# HISTORIC AND DESIGN REVIEW COMMISSION

HDRC CASE NO:	2018-389
ADDRESS:	102 LOVERA BLVD
LEGAL DESCRIPTION:	NCB 9006 BLK 14 LOT 38 39 & E 12.5 FT OF 37
ZONING:	R-4 H
CITY COUNCIL DIST.:	1
DISTRICT:	Olmos Park Terrace Historic District
APPLICANT:	Mayes White
<b>OWNER:</b>	Mayes White
TYPE OF WORK:	Installation of a new curb cut and driveway
<b>APPLICATION RECEIVED:</b>	October 24, 2018
60-DAY REVIEW:	December 23, 2018

The applicant is requesting a Certificate of Appropriateness for approval to install a new 10 foot wide driveway and curb cut in the front yard of 102 Lovera Blvd.

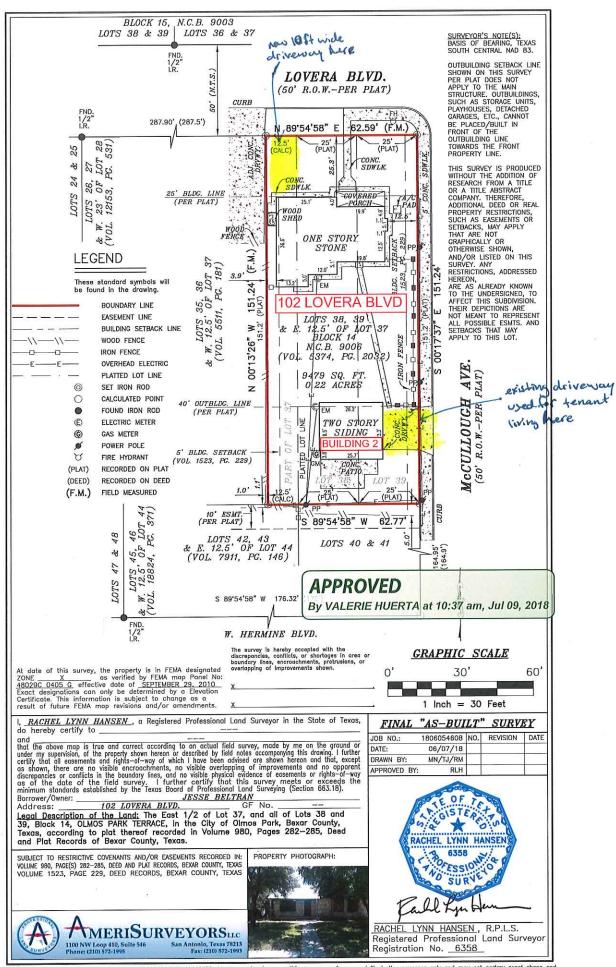
- b. CURB CUT AND DRIVEWAY EXPANSION The applicant has proposed to install a new concrete driveway and curb cut to accommodate front yard parking. The new driveway will be installed directly adjacent to the neighbor's driveway to the east. According to the Historic Design Guidelines, historic driveways were typically no larger than 10 feet in width. The Guidelines also state that new curb cuts and driveways should not disrupt the continuity of the streetscape and should follow the driveway development pattern that characterizes the street and the district. The proposed new curb cut and driveway are a significant departure from residential front yard configurations in the Olmos Park Terrace Historic District. Typically in the district, corner lots feature rear parking with access to a rear accessory structure. This is the current parking configuration of 102 Lovera Blvd. There is no evidence of the proposed front parking configuration in the district when rear parking present off a side street. Staff does not find the proposal consistent with the Guidelines.

Staff does not recommend approval based on findings a through b.
